FINDINGS AND RECOMMENDATION OFFICE OF PLANNING AND ZONING ANNE ARUNDEL COUNTY, MARYLAND

CASE NUMBER: 2024-0091-V

REQUEST

The applicant is requesting variances to allow a dwelling with less setbacks than required on property located at 212 Riverside Road in Edgewater.

ADMINISTRATIVE SITE PLAN

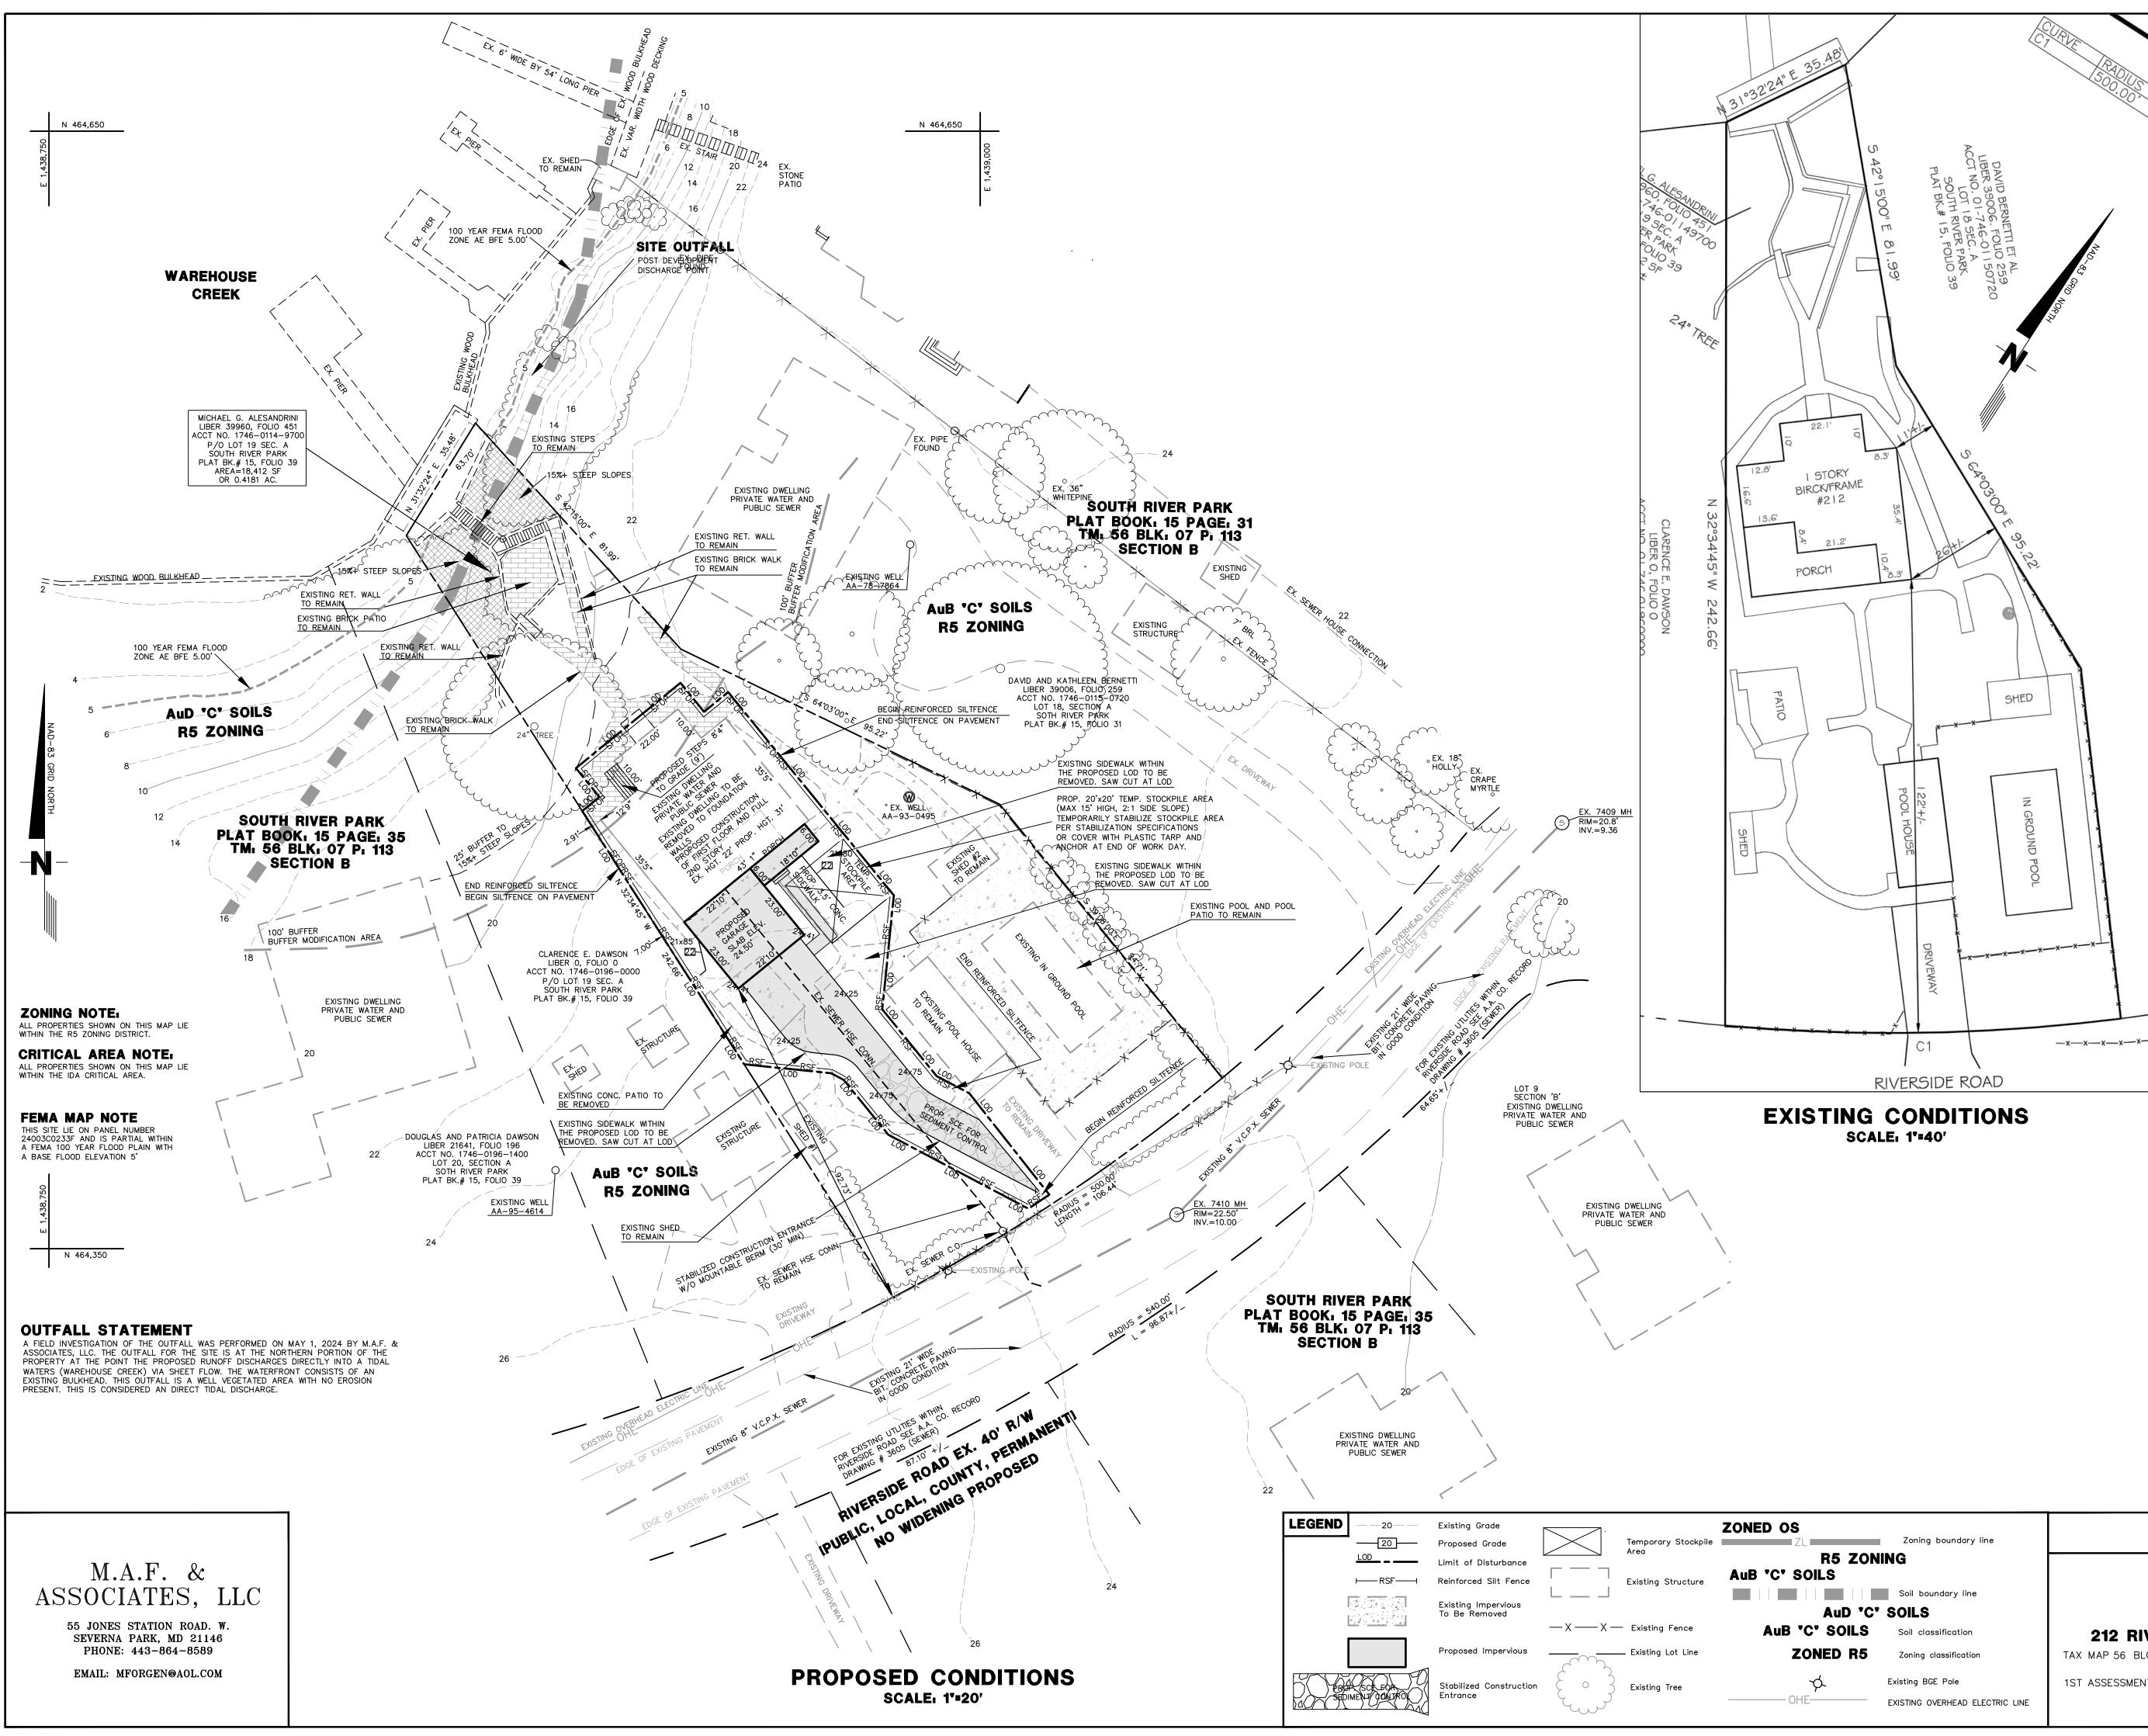
Menu	Cancel	Help		
			 Habianu Zeleke Current Status Complete w/ Comments Action By Habtamu Zeleke Comments Variance request: Variance to allow a dwelling with less setbacks than required. 1. How to manage the runoff water quality from the proposed garage? is there additional environmental mitigation, reforestation preparation, and improved water quality? 2. Provide an ESD map that shows clearly how the existing impervious surface areas are being treated. Please note that all surfaces must be treated and management at a specific location to account for untreated areas is not permitted for single-family home development. 3. Based on the plan provided, it appears that the property will be served by a private well and a public sewer. 4. The stormwater management, utility/Engineering design additional review, and comments for the site shall occur at the grading permit stage. 	Due Date 06/03/2024 Assigned to Depart Engineering Status Date 06/03/2024 Overtime No Start Time

Based on the above comments and proposed site design, this office does not support this request. End Time 	Hours Spent
			Billable No Time Tracking Start Date In Possession Time (hrs)	0.0 Action by Departme Engineering Est. Completion Da Display E-mail A
			Estimated Hours 0.0 Comment Display in ACA	Display Comme
			 All ACA Users Record Creator 	
			Licensed Professional Contact	
			Task Specific Information
